# Technical Newsletter

Jun 2025 Service Operation Team

Changes to the TNV-C8014RM\_C8034RM GASKET TOP Shape

● New features (1) : WisePower

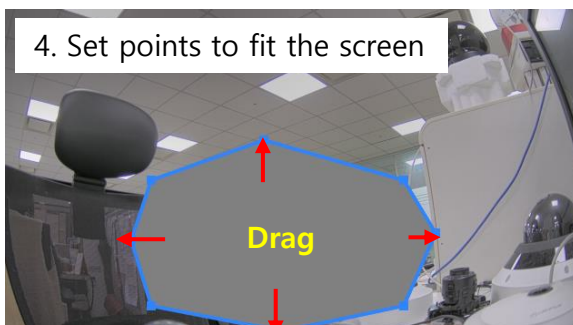
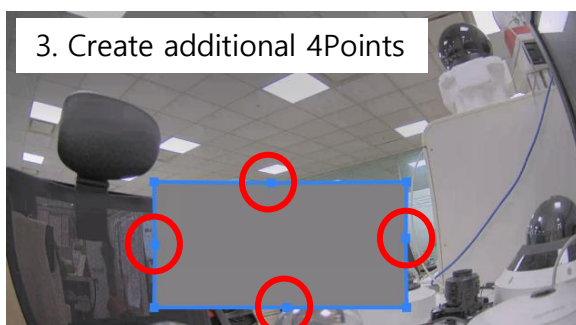
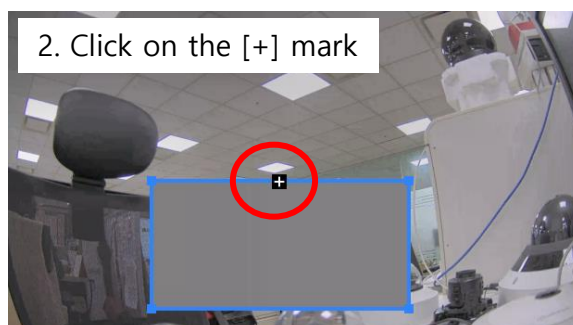
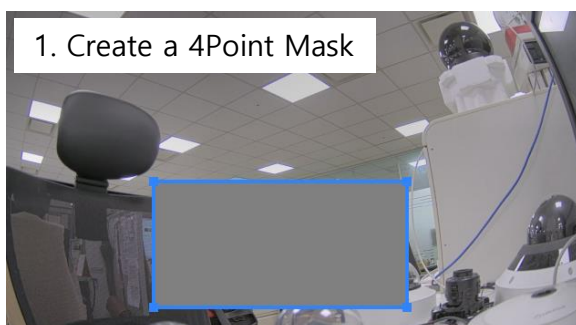
- Provides users with various power-related information (request, allocation, maximum, average, current power consumption, PoE class, etc.)
- Reduces power consumption by reducing the IR's visible distance when ECO Mode is set.
- WisePower Setting: [Setup] → [System] → [WisePower]

### ● New features (2) : Privacy masking with 8 Point support

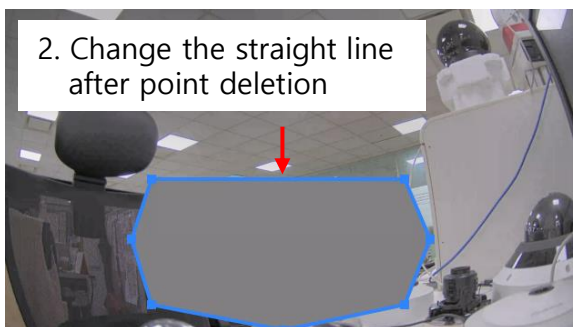
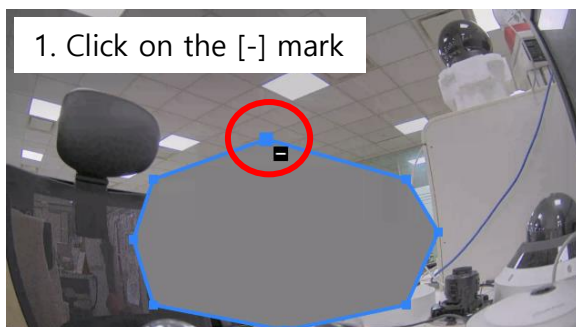
- Privacy Masking function expanded by changing from 4-point support to 8-point support.
- After setting the initial 4-point areas, you can add up to 4 points more.
- Privacy Mask Setting : [Setup] → [Video & Audio] → [Video Settings] → Check the [Enable Privacy Area] option
- Point Addition: Set 4 Points → Name the Mask → Click the  mark created when the mouse overlaps in the middle of the line → Add 1 Point → Set the points to fit the screen
- Point Deletion: 8 Points available → Click the  mark created when the mouse overlaps on the Point → Confirm Point deletion
- Example of adding points

- Example of deleting a point
